Notice of Decision

FILE NO.: Administrative Adjustment of Height Standards,
AAS16-00008

PROJECT NAME: Sunset 7 Apartments

REQUEST: Administrative Adjustment to the Height Standards to increase
the height of the building from the base height of 40 feet to 45'-
10".

355 E. SUNSET WAY, ISSAQUAH WA.
SUN AND SHADOW ANALYSIS

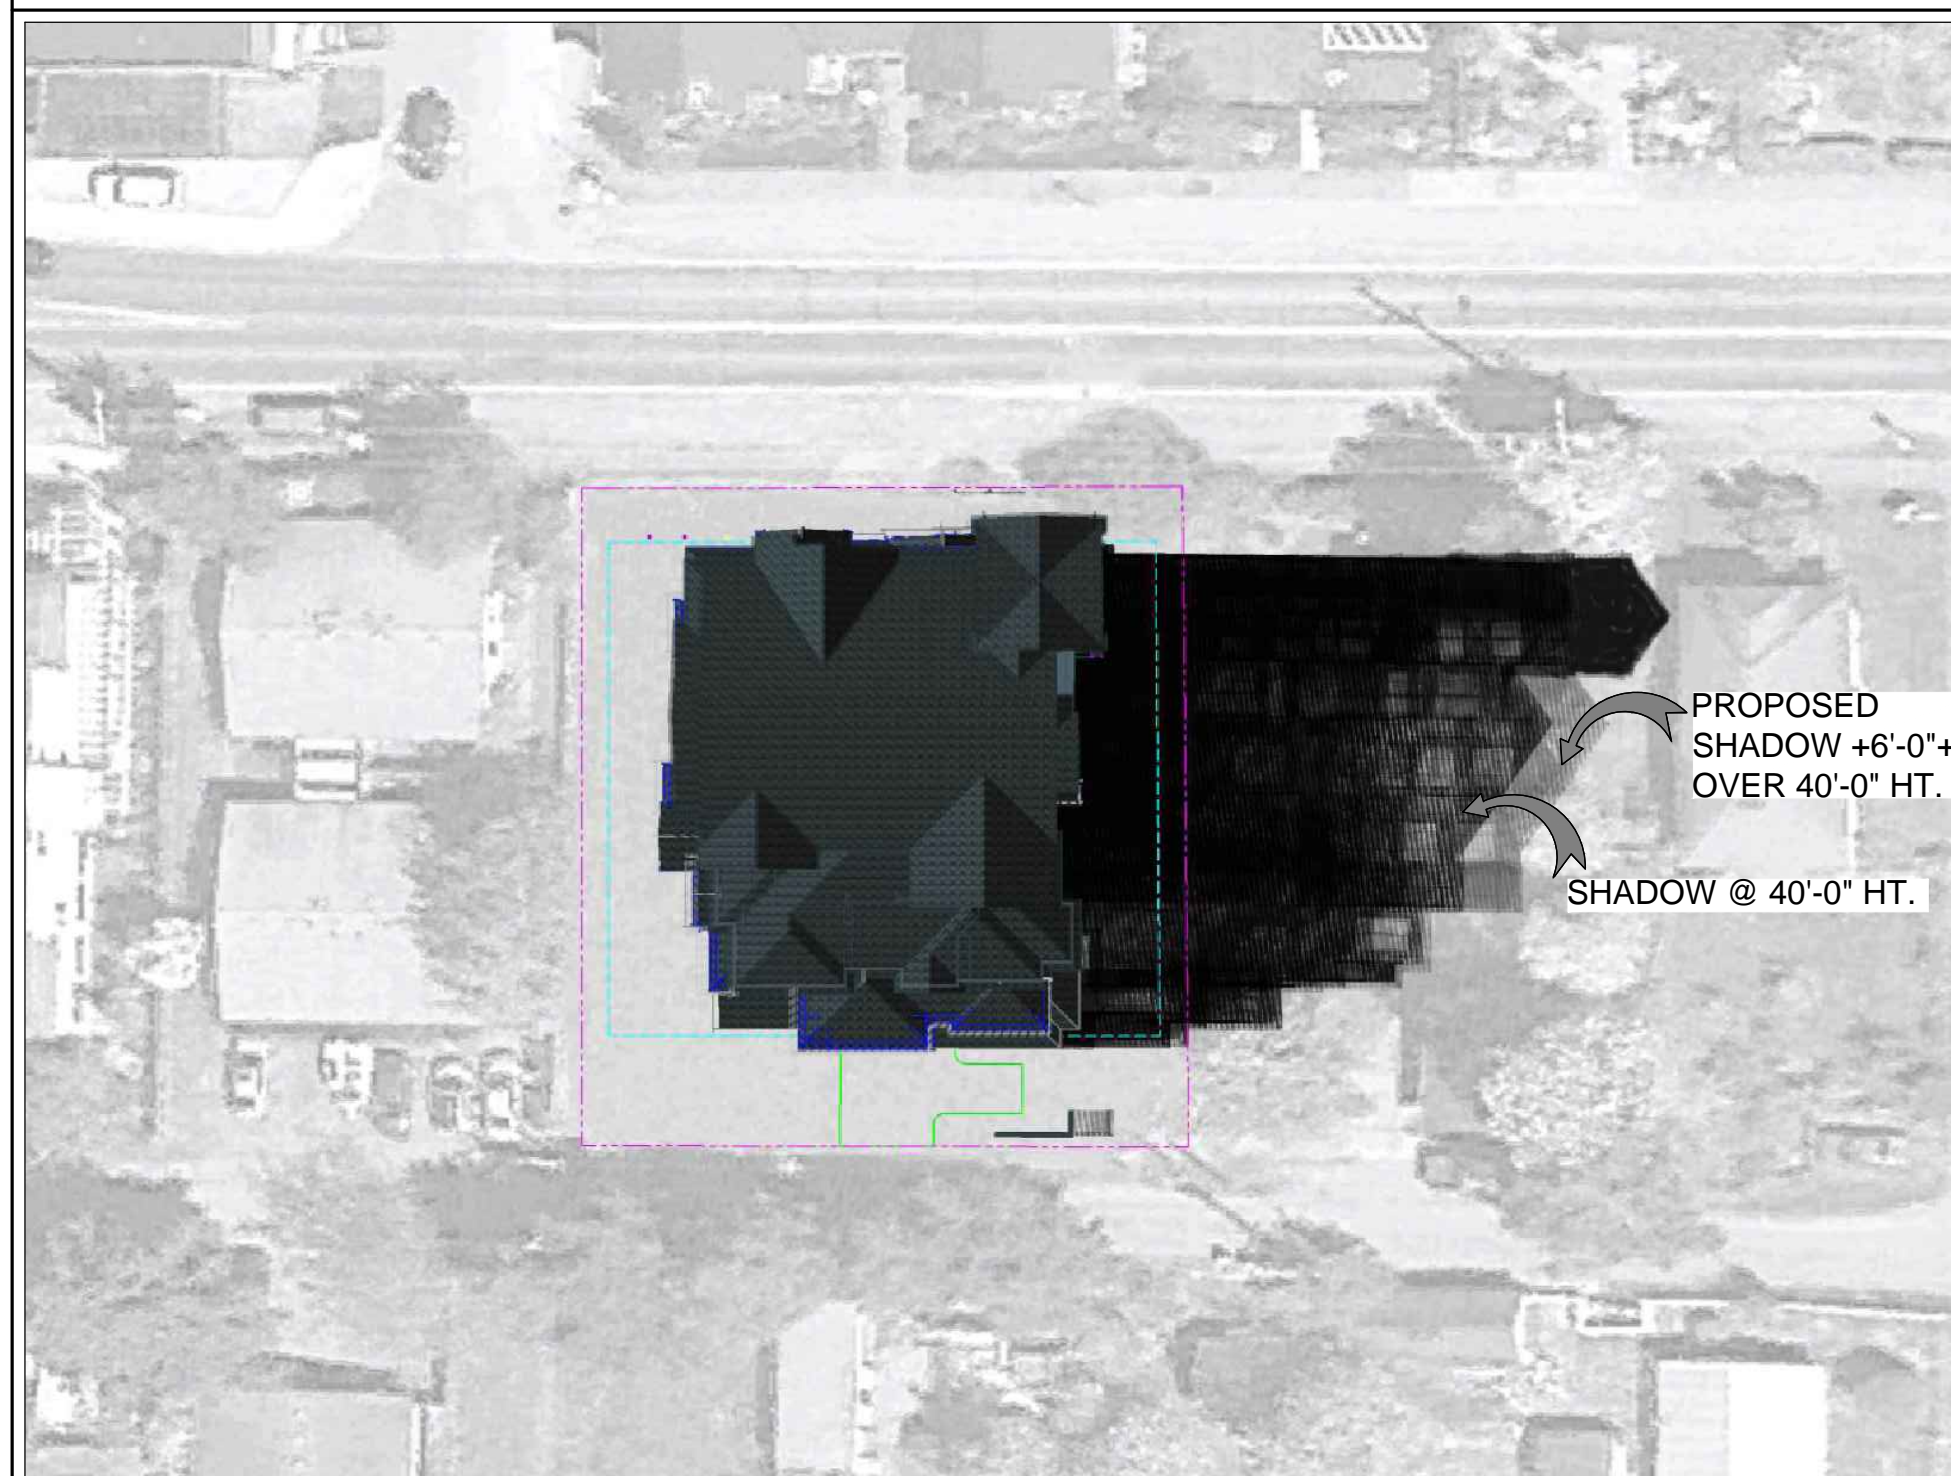
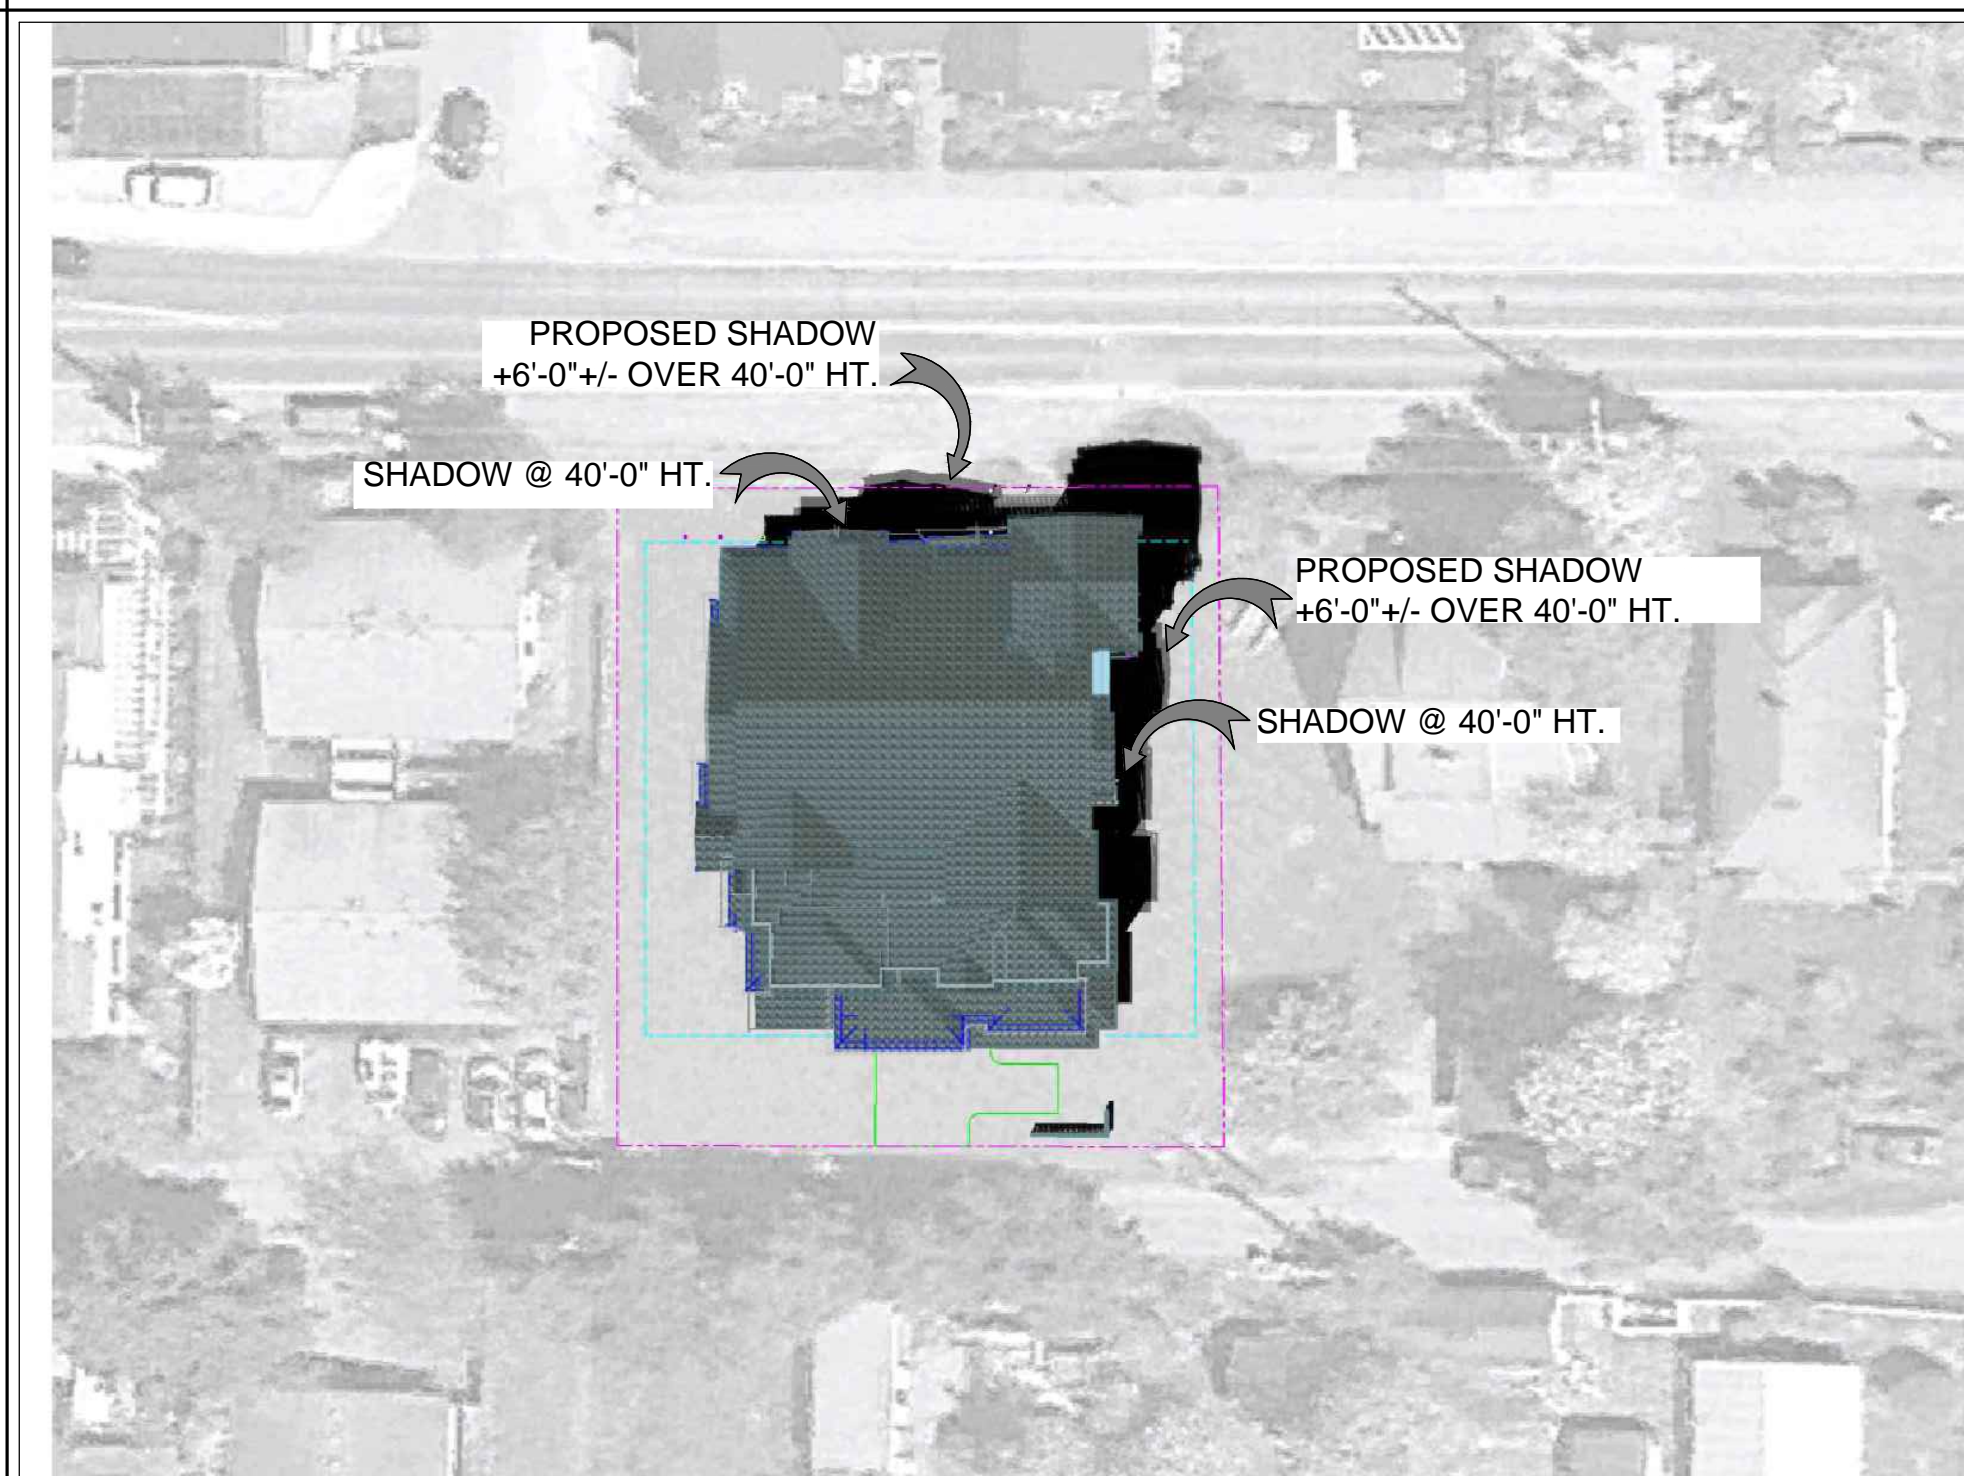
Staff Analysis: A Sun and Shadow Analysis (Attachment E) shows the building casting the longest shadow at 5 p.m. on the adjacent property to the east. The side yard and the front yard of the property to the east will be in the shadows. At 3 p.m., only the side yard and a portion of the front yard will be in the shadows. No shadows are cast on the properties across the alley located on the south. The west elevation is amply modulated vertically and horizontally, so that the upper floors step back further. The result is a shorter shadow cast on the west neighboring property. The Sun and Shadow Analysis compares the amount of area in the shadows under 2 scenarios: if the building is built within the 40-foot base height and as proposed, with the increased height of 6 feet 10 inches. The shadow analysis shows that the difference in area that will be shaded due to the increase in building height does not have any adverse impact because the additional shaded area is cast on the roof of the neighboring properties.
